DS-K1T680 Series MinMoe Terminal Release Note (2021-12-10)

Device Model: DS-K1T680D(F)-E1 DS-K1T680D(F)W DS-K1T680D(F)G DS-K1T680D(F)G1 Naming Rule: D for M1 card, Desfire card, Felica card E1 for POE, W for Wi-Fi, F for fingerprint G1 for 3/4G, supported in Australia, Taiwan (China) and Latin America; G for 3/4G, supported in Europe, the Middle East, Africa, India, and Most Areas of Asia-Pacific (excluding Japan and Taiwan (China))	Firmware Version	ARM : ACS_680_AI3_EN_ STD _V3.2.33_build211122 ACS_680_AI3_EN_ NEU _V3.2.33_build211122
	SDK	Latest version
	iVMS-4200 Version	Latest version

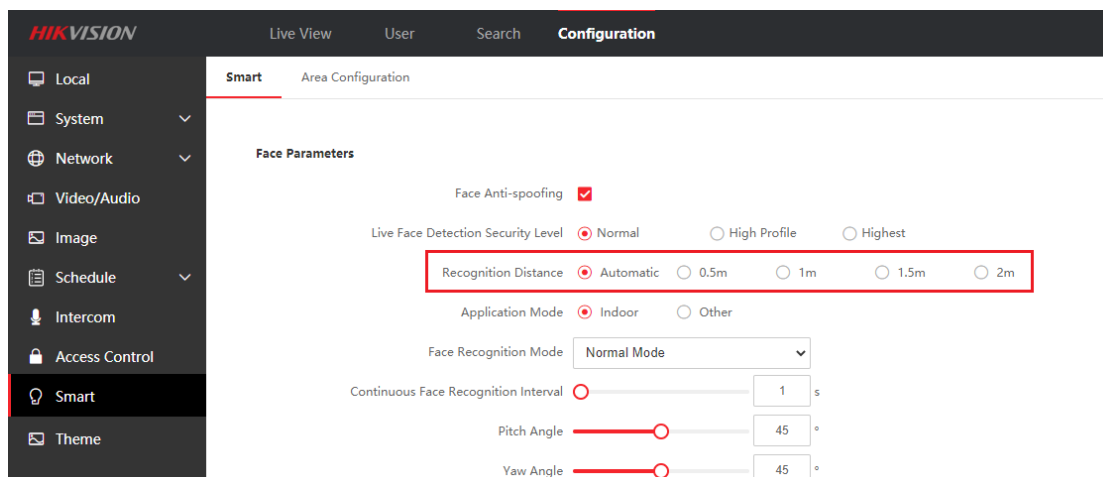
1. Add Hik-Connect menu in device UI Menu → Comm. The function is disabled in default.

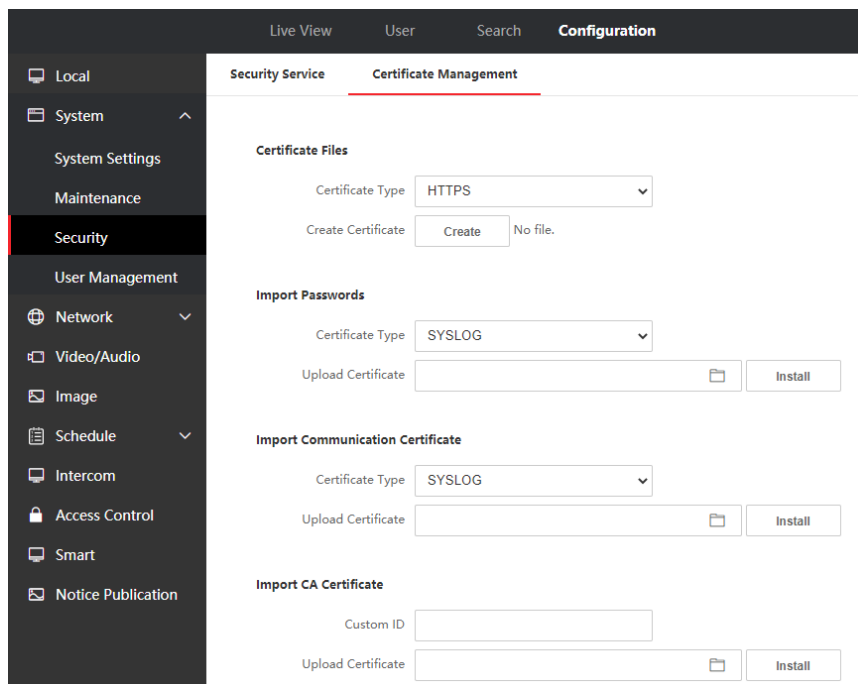
1. Support https feature

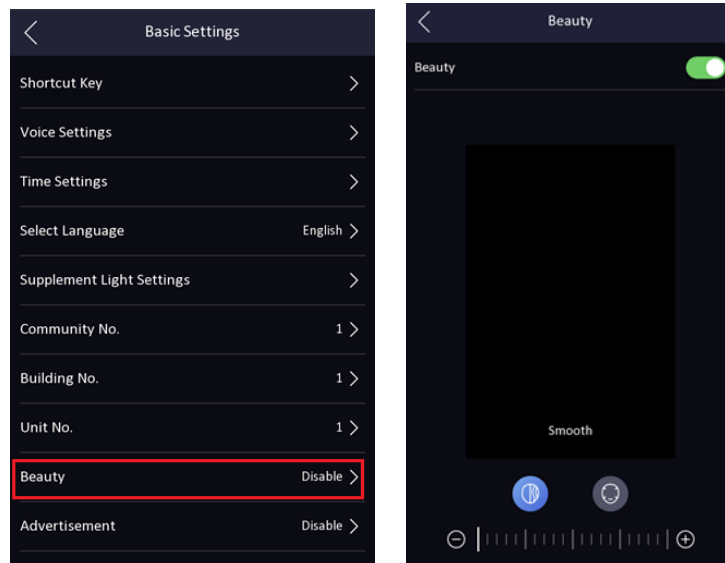
2. Support Hik-ProConnect platform docking
3. Add beauty function to adjust smooth and whiten parameter.

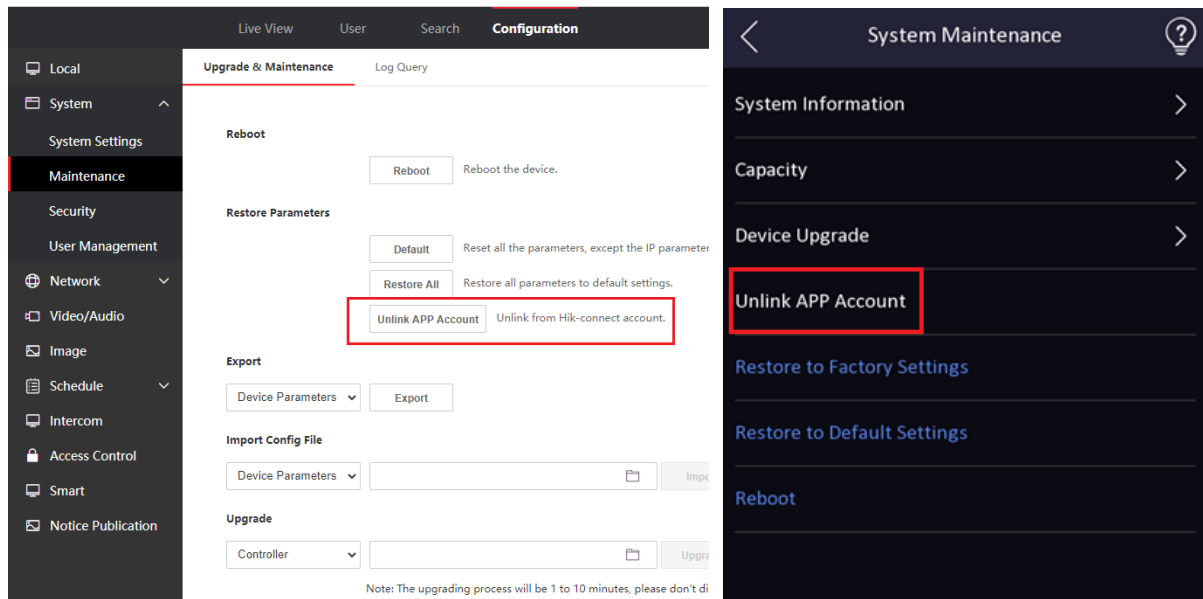
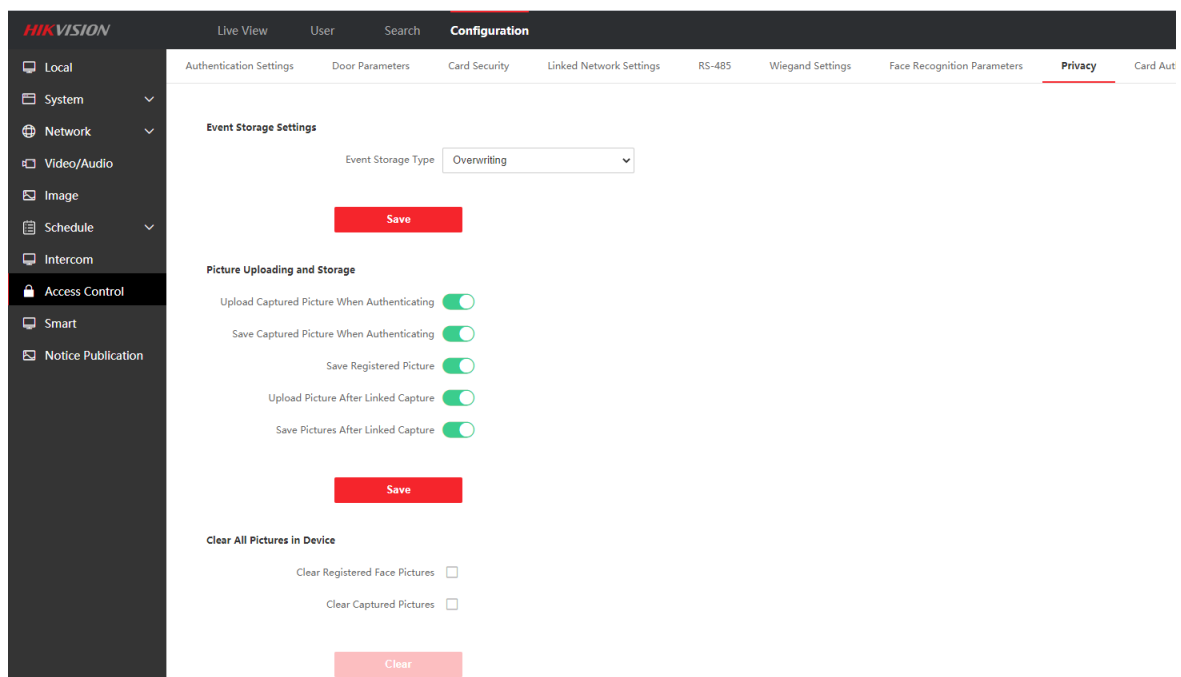
6. Support unbind device with hik-connect account on SADP tool, local UI and web

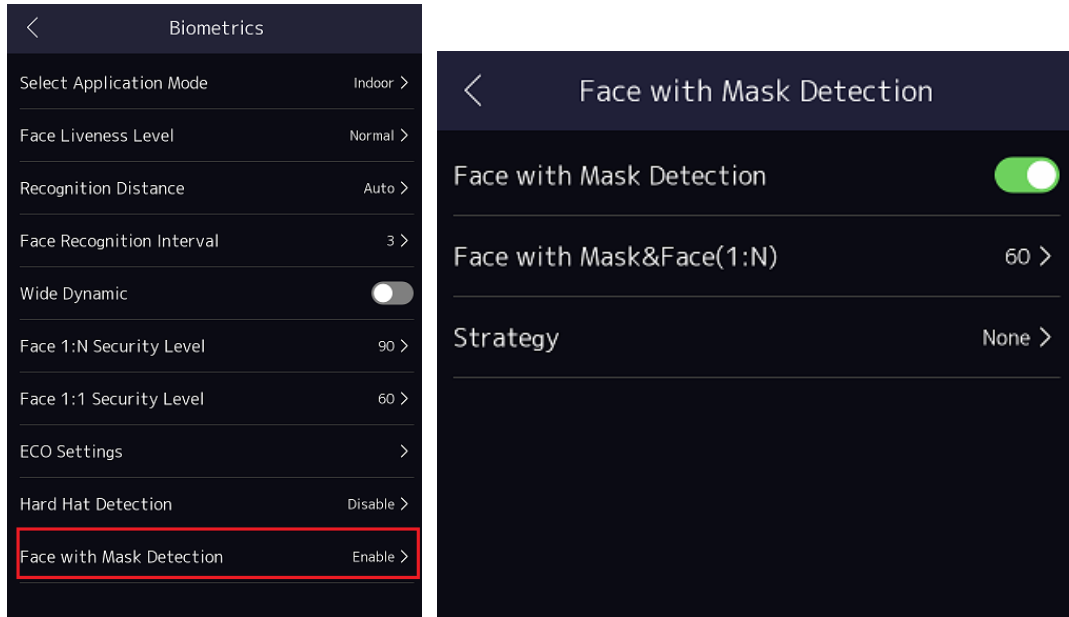
7. Add privacy protection, support event Storage Settings, Picture Uploading and Storage, Clear All Pictures in Device

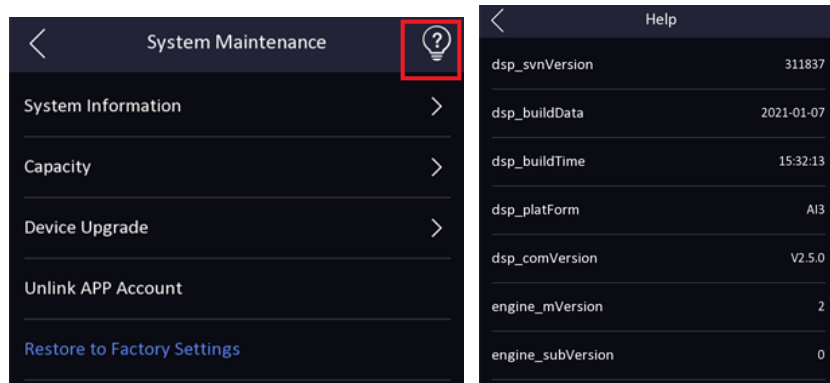
8. Add face mask detection function(enabled in default);

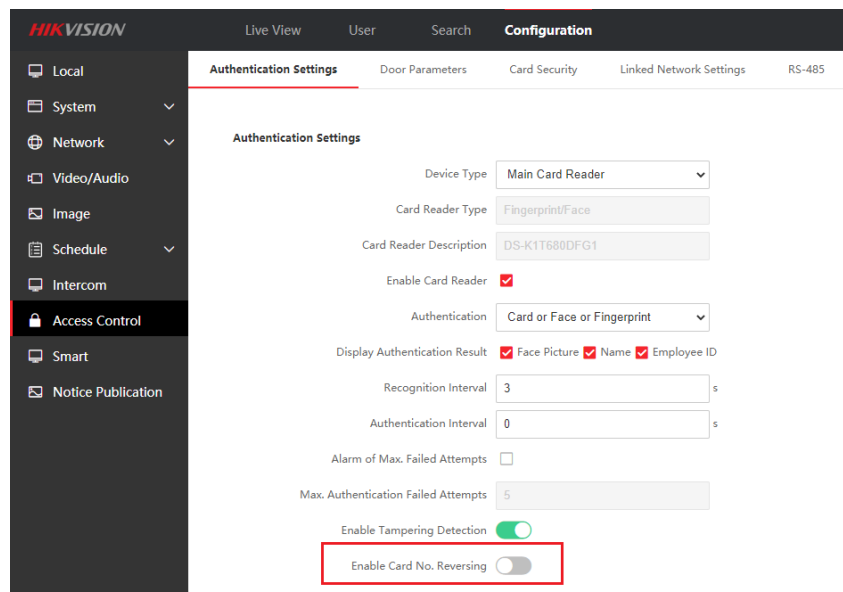
9. Add help interface to check system module version for technical support (long press for 3s).

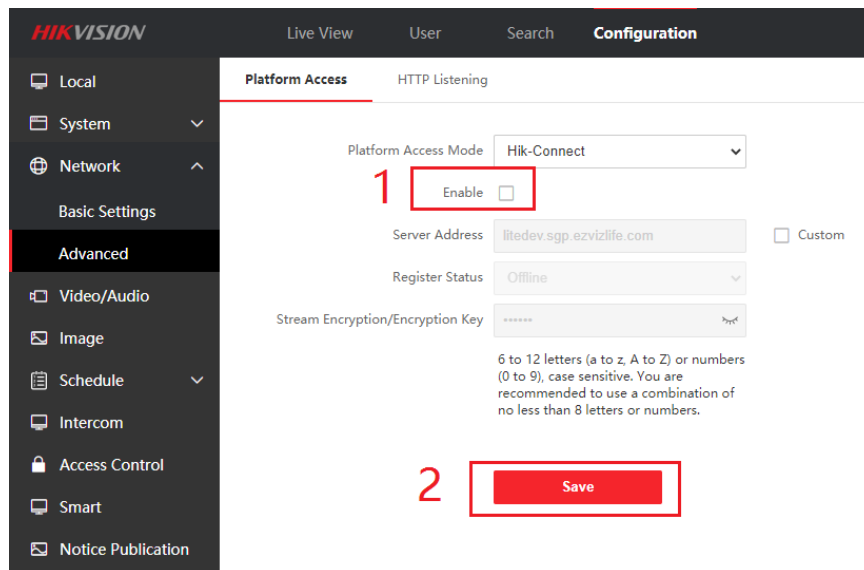
10. Add card No. reversing function (external reader not support)

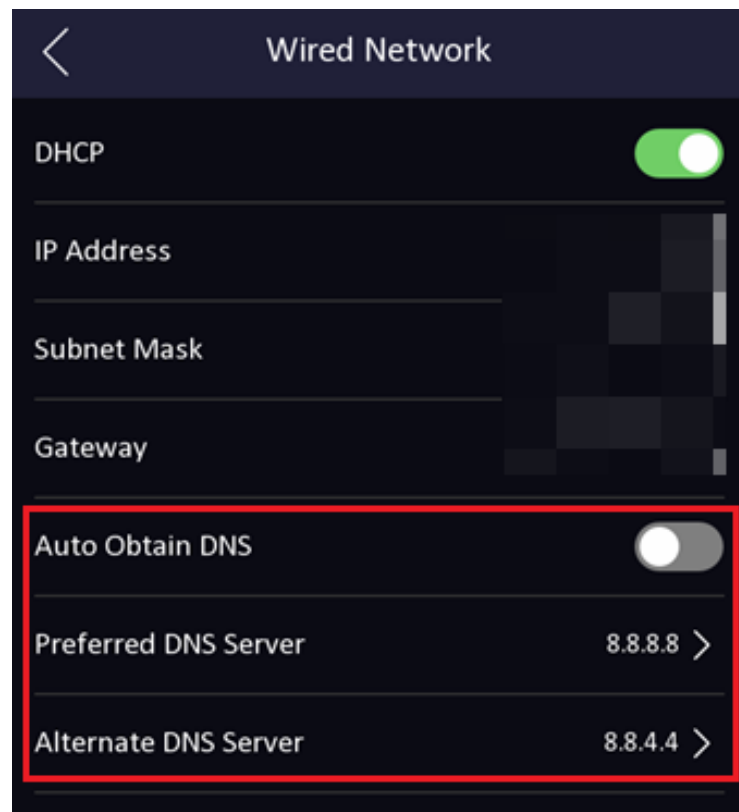
- Hik-Connect function is turned off in default for privacy protection, if customer want to manage device from App, please turn on manually in the web.

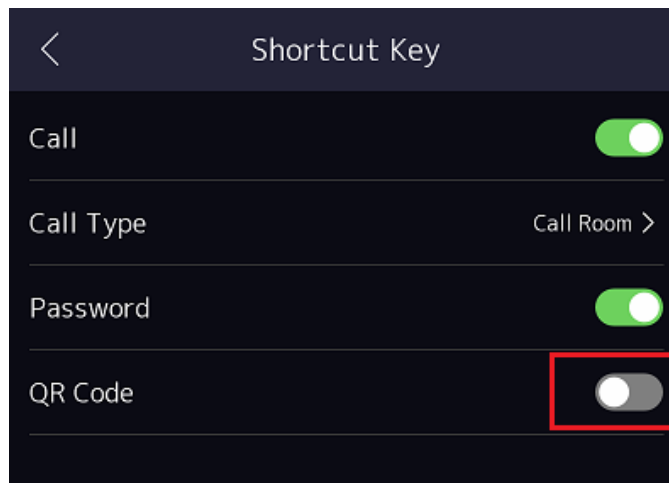
- DNS can be configured from device UI in menu → Comm.-->Wired Network

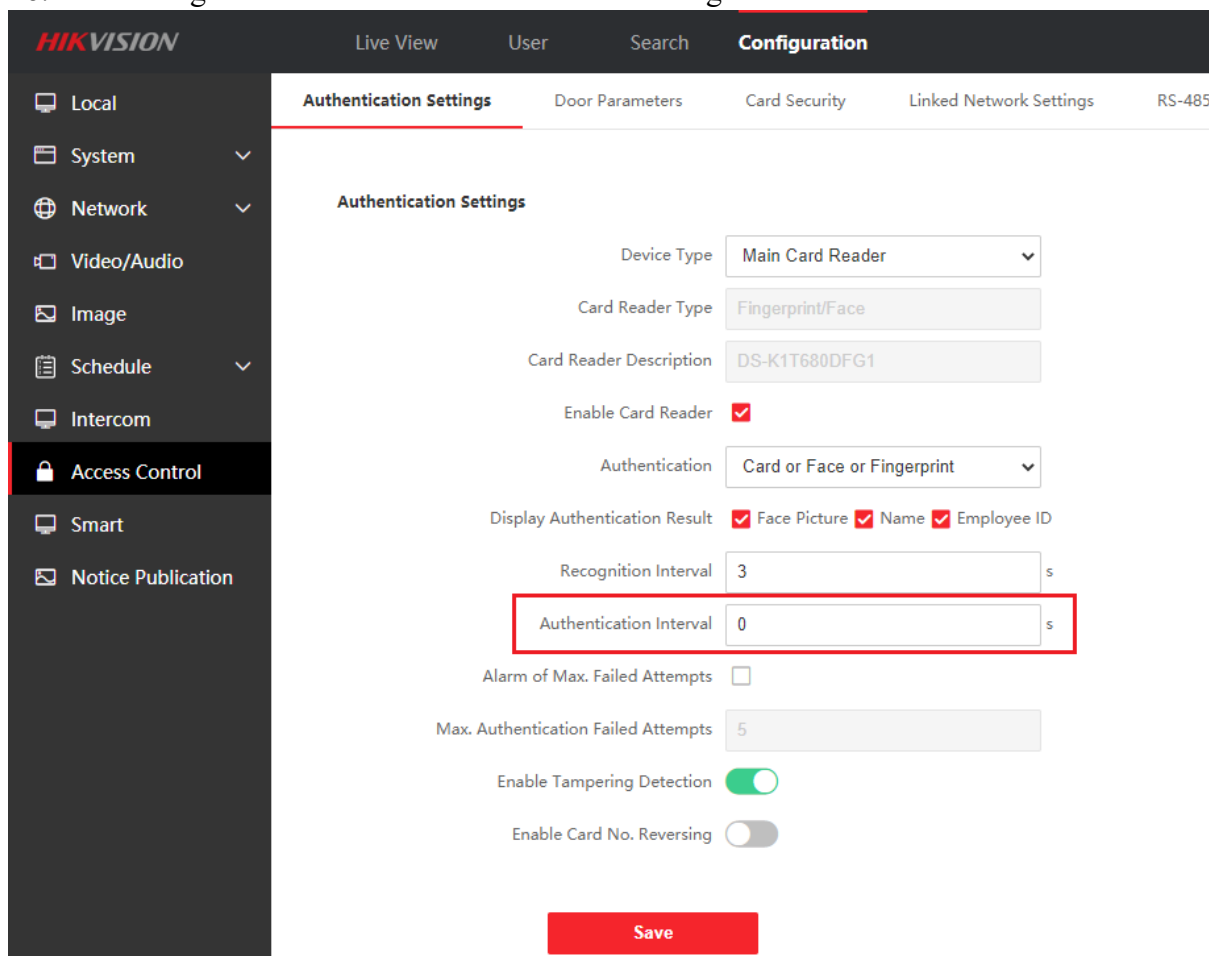
- After disable QR code shortcut from the menu, device will support QR code and face verification at the same time.
